COTTONWOOD GROVE 3RD ADDITION

Re: S/D 98-3 -- Final Plat of COTTONWOOD GROVE 3RD ADDITION

STAFF REPORT

CASE NUMBER: S/D 98-3 - COTTONWOOD GROVE 3RD ADDITION

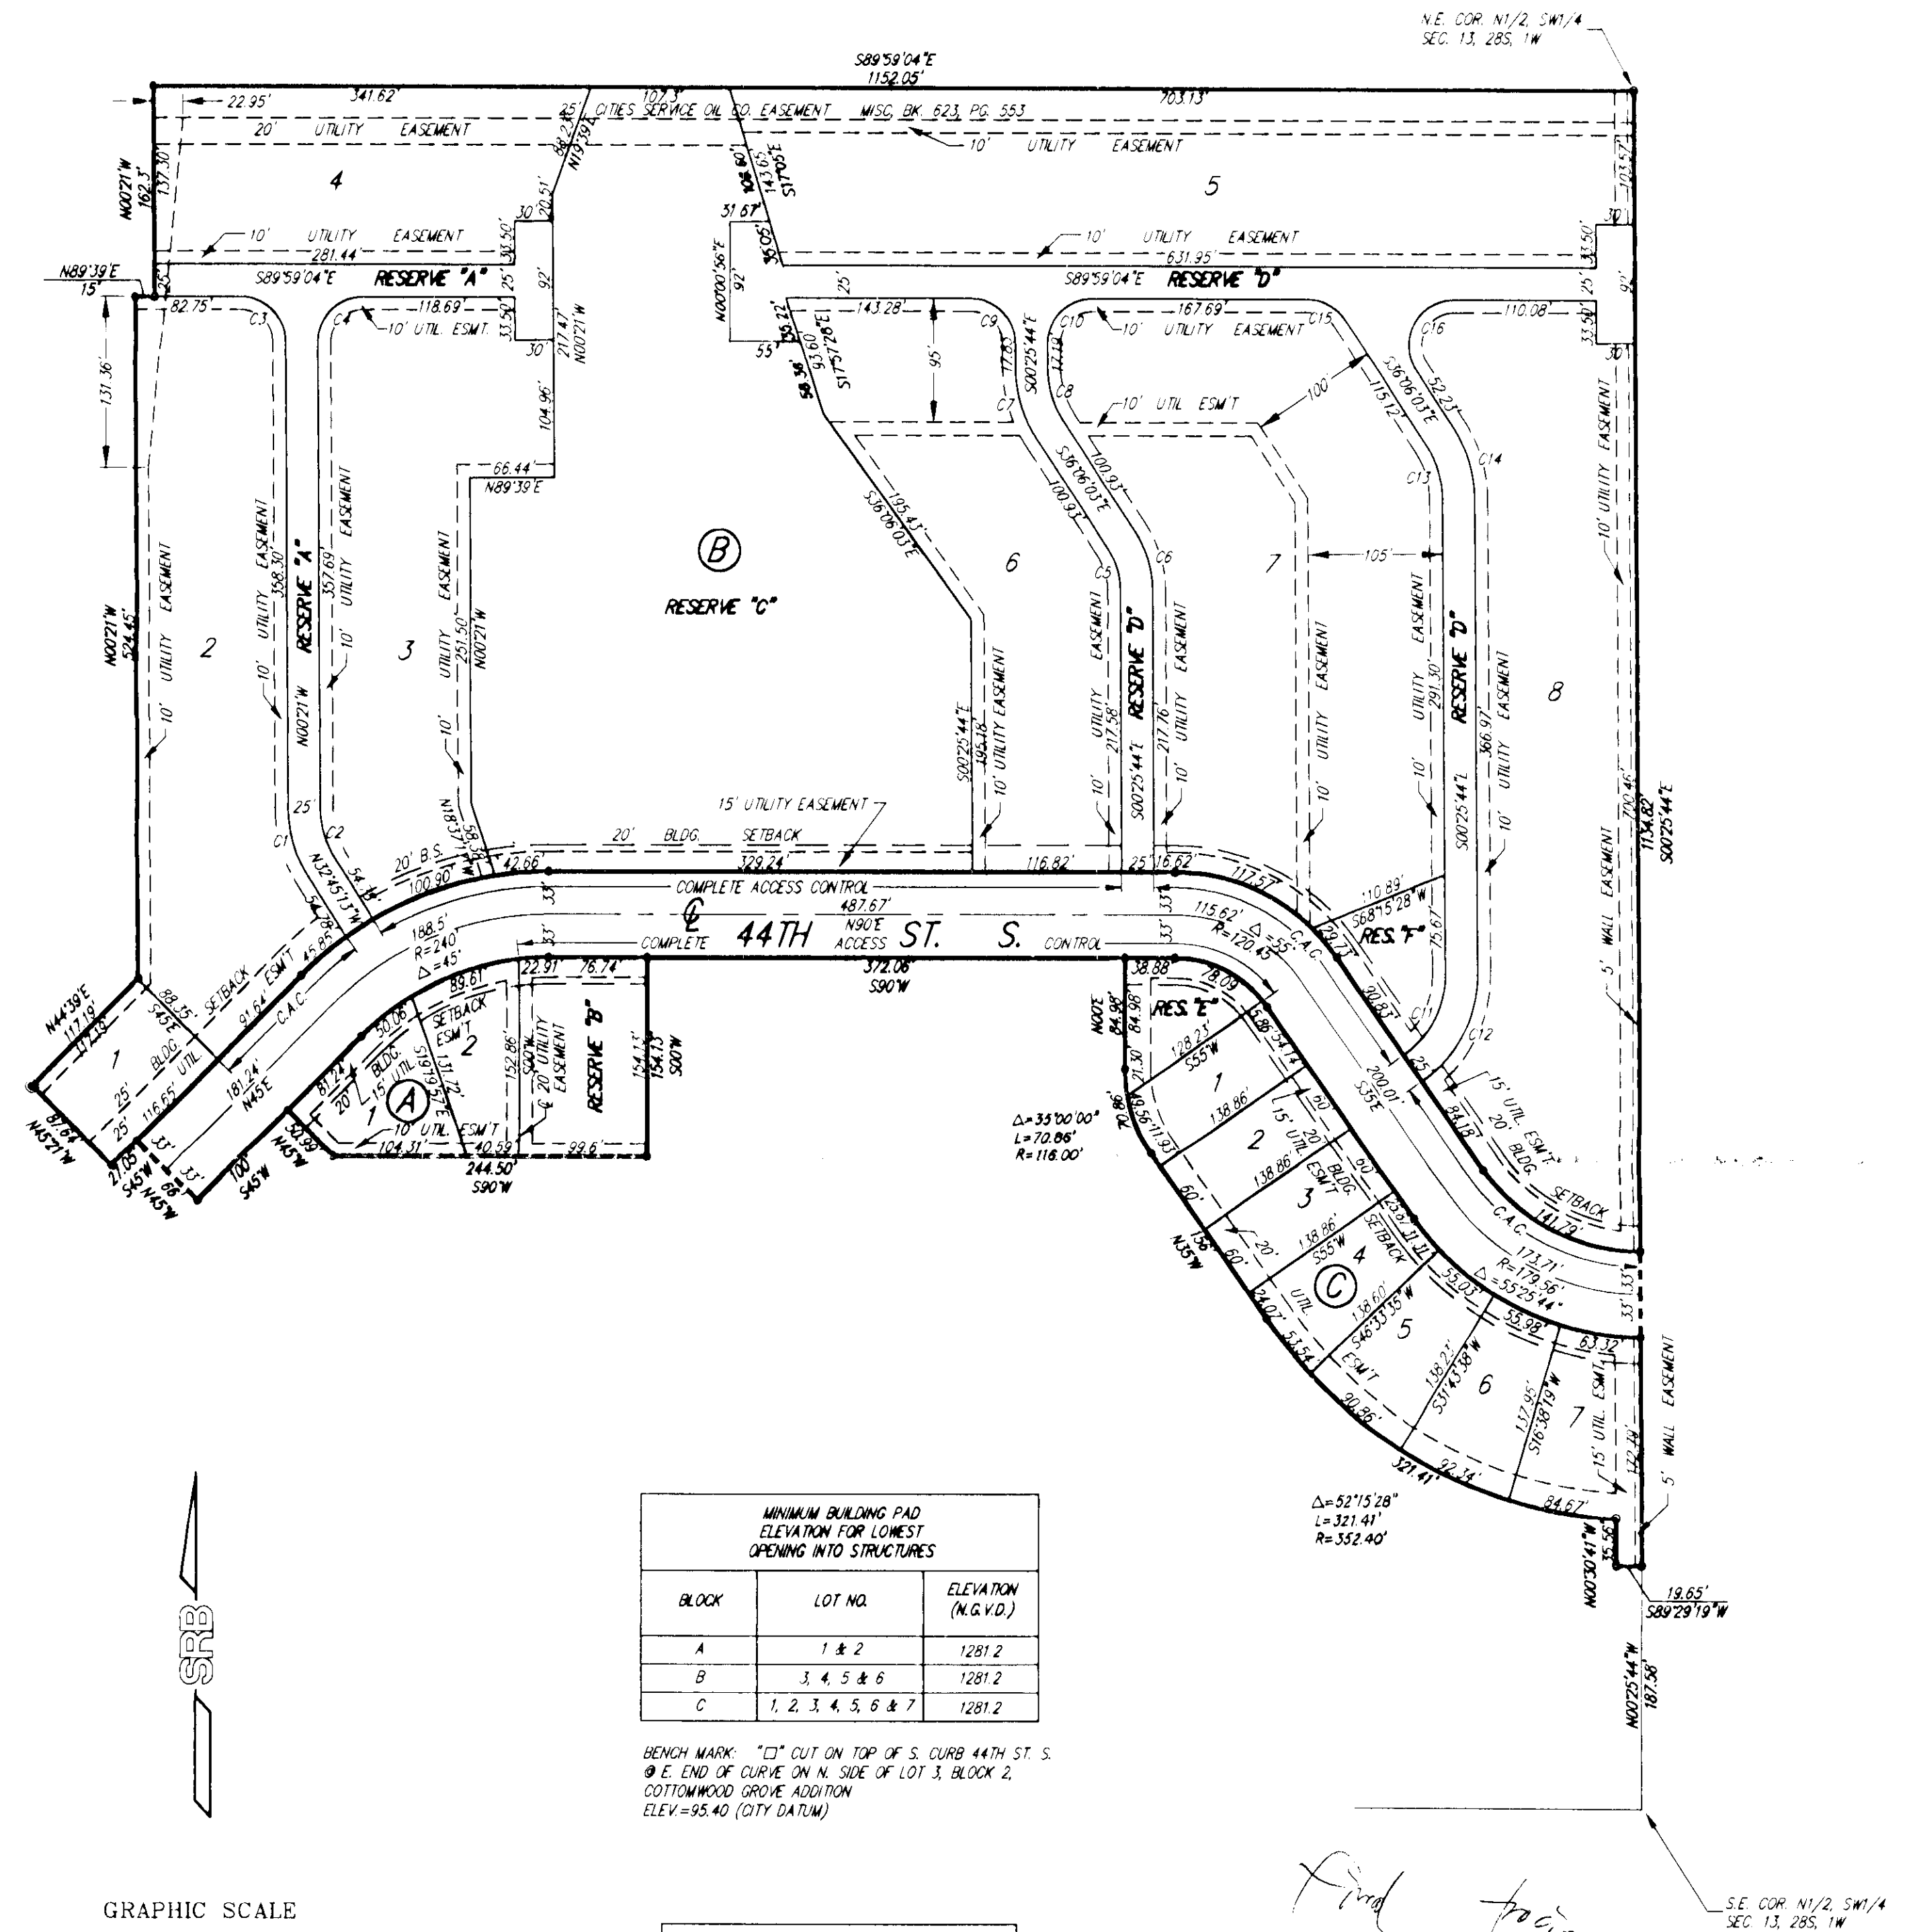
- A. The applicant needs to guarantee the extension of City water and sanitary sewer to serve the lots being platted. **City Engineering** needs to comment on the need for any additional guarantees for municipal services. **City Engineering requests a sanitary sewer layout to determine location of easements.**
- B. If improvements are guaranteed by petition, a notarized certificate listing the petitions shall be submitted to the Planning department for recording.
- C. **City Engineering** needs to comment on the status of the applicant's drainage plan. **The drainage plan is approved. A guarantee will be required and minimum pads need to be platted for the lots adjacent to the lakes.**
- D. Complete access control shall be dedicated along 44th Street South except at the location of the private street reserves **and except along the single-family lots.**

The final plat indicates the requested access controls. **The final tracing needs to denote access controls along the south side of 44th St. South.**

- I. The applicant shall also guarantee the paving of 44th Street South to collector street standards, including sidewalks on both sides.
- J. The final plat shall indicate temporary turnarounds at the terminus of the private streets at the east and west line of the plat, and adjoining Reserve C. A "T"-type turnaround may be provided as an alternative to the standard circular turnaround for the terminus of the private streets adjoining Reserve C. Dedication of the temporary easements by separate instrument shall be provided.

- K. Fire Department needs to comment on the acceptability of the private street access. *Fire Department requests a temporary cul-de-sac at the terminus of 44th St. South along the east line of the plat.*

- L. The applicant shall submit a copy of the instrument which establishes the pipeline easement on the property, which verifies that the easement shown is sufficient and that utilities may be located adjacent to and within the easements.

- M. The applicant's agent shall determine any setback requirements for the pipeline by researching the text of the pipeline agreement. If a setback from the pipeline easement is provided for in the pipeline easement agreement, it shall be indicated on the face of the plat.

- W. The applicant is reminded that in accordance with the Protective Overlay, a landscape buffer is required along the north and east lines of the plat along with a landscaped street yard in accordance with the City Landscape Ordinance.
